Planning Commission Staff Report

Project Type: Sign Package

Meeting Date: February 27, 2017

Description: **Highland on Conway (Delmar Gardens III), Sign Package:** A request for a Sign Package to establish sign criteria for the Highland on Conway development located north of I-64, south of Conway Road, east of Chesterfield Parkway, west of Timberlake Manor Parkway.

Figure 1- Attached Wall Signs

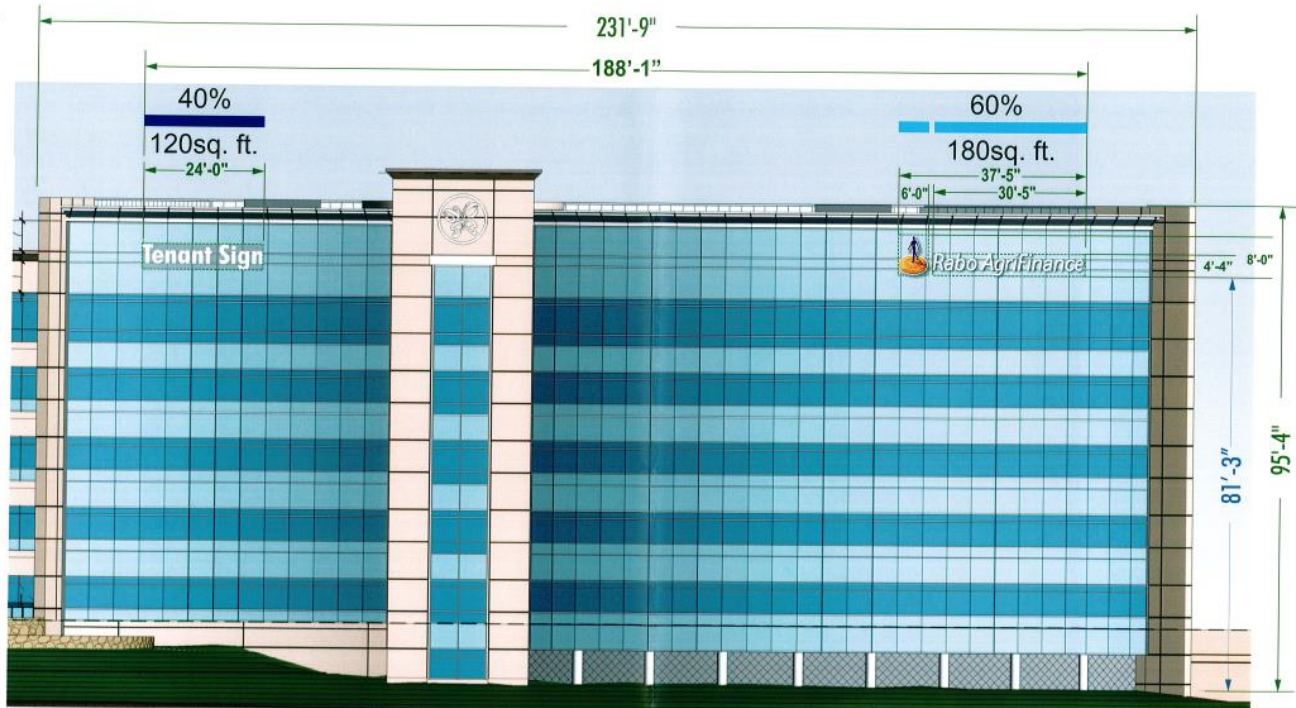
The UDC permits one (1) attached wall sign per two (2) walls. The applicant is requesting the use of two (2) attached wall signs per one (1) wall of their building (as shown below in figure 1). The proposed sign package would preclude any additional wall signs on any other façade of the building.

The request is threefold. First is for an additional wall sign on the front of the façade without increasing the overall amount of area permitted for signage. This request is consistent with other sign packages approved in this area, such as Timberlake Corporate Center which allows two wall signs on the southern façade. Staff has no concerns with this request.

Figure 2- Freestanding Business Identification Sign(s)

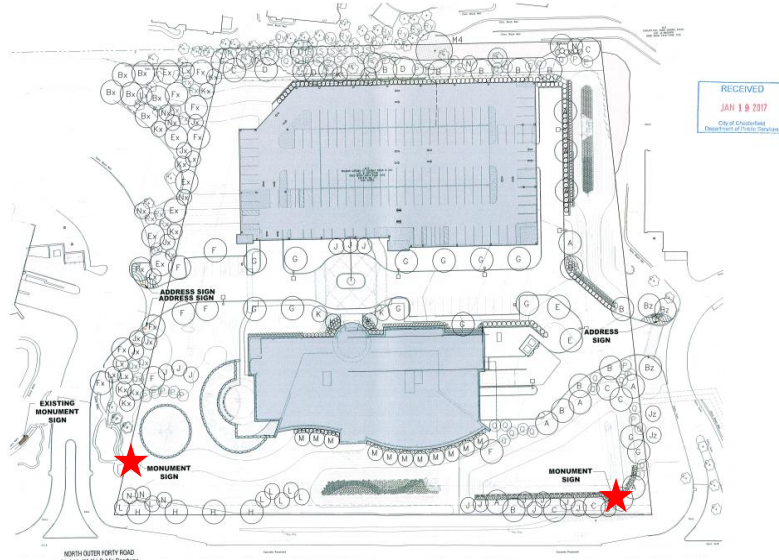
The request includes two (2) business identification signs, as shown in Figure 2 below. The UDC states:

The inclusion of the second proposed monument sign necessitates the proposed Sign Package to allow for flexibility. As shown in Figure 5 below, there are no developments along this corridor which have two monument signs. The applicant has submitted their justification in their narrative of the sign package attached hereto, stating that these signs are necessary due to the fact that they have two entrances and want to ensure the most clarity for drivers.

Finally, the applicant is requesting two (2) monument signs to exceed 50 square feet in outline area, and to exceed 6 feet in height. As previously mentioned, Staff continues to have concerns with this request as there is no other development in this area with 190 square feet of monument signage and this would set a precedent for development in this area.

Staff has reviewed the Sign Package and found the proposal to be consistent with the purpose and intent of the UDC with the exception of the request for two monument signs of 95 square feet in outline area and 12’ 2” in height. Staff recommends approval of the proposed Sign Package for the Monarch Center Development with one of the following conditions:

One monument sign is permitted with 95 square feet in outline area and 12’ 2” in height.

OR

Two monument signs are permitted with 50 square feet in outline area and 6’ in height.

Figure 3- Proposed Monument Sign

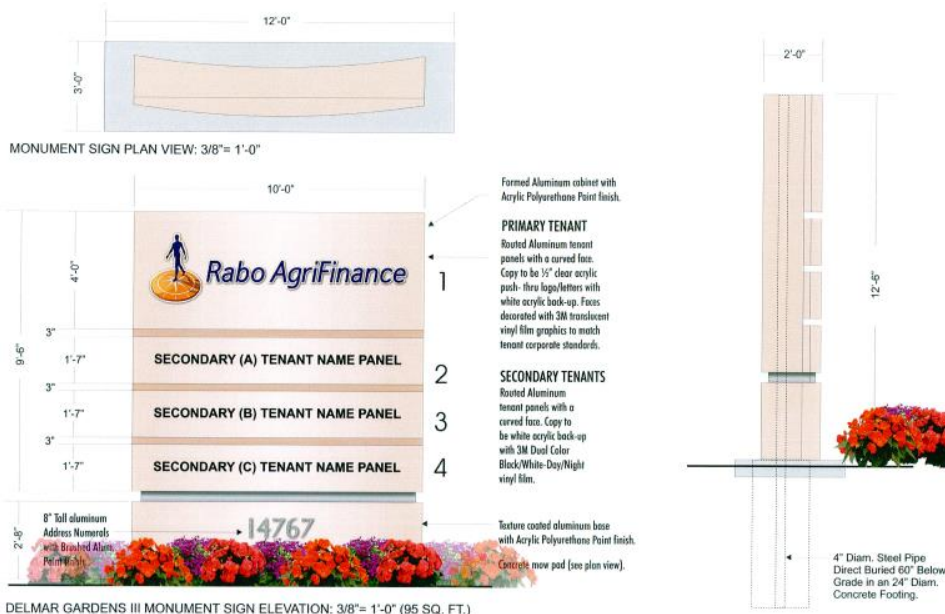
The second part of the request pertaining to freestanding monuments, is to exceed 50 square feet in outline area and 6 feet in height for both signs. The proposed signs are 95 square feet in outline area and 12' 2" in height. The applicant had indicated that they would like to mimic the monument design of the adjacent office building; the proposed design is shown in Figure 3 below. While they are not under the same development or sign package, the buildings incorporate consistent architecture. An image of the existing signage on the adjacent development can be seen in Figure 4.

Additionally, freestanding monument and directional signs must include landscaping. The applicant has indicated that perennials will be used at the base of the signs, however, the exact arrangement will be decided at the Zoning approval phase.

Figure 7- Directional Signs Locations

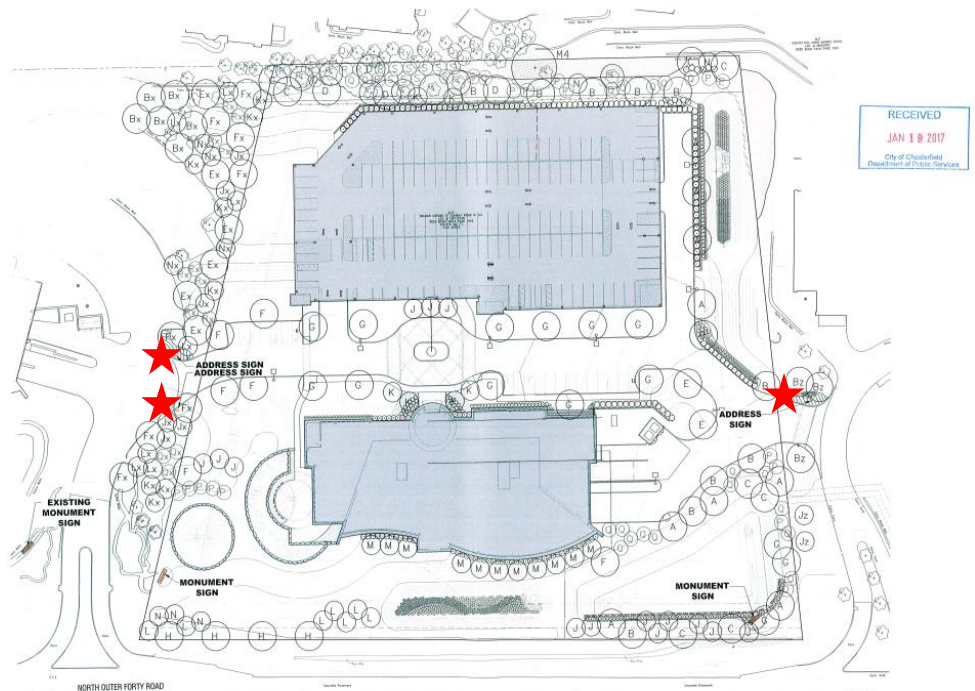
The applicant is requesting the use of three directional signs as shown in Figure 6. The locations of these signs would be at the cross access entrances as shown on the site plan in Figure 7. These proposed signs are limited to 3.5 feet in height and 6 square feet in outline area. This request complies with the regulations of the UDC, and Staff has no concerns with this request.

The second request is for three (3) directional signs limited to 3.5 feet in height and 6 square feet in outline area. The Unified Development Code allows up to 6 feet in height and 10 square feet in outline area. This proposed directional signage is within these standards and Staff therefore has no concerns with this request.
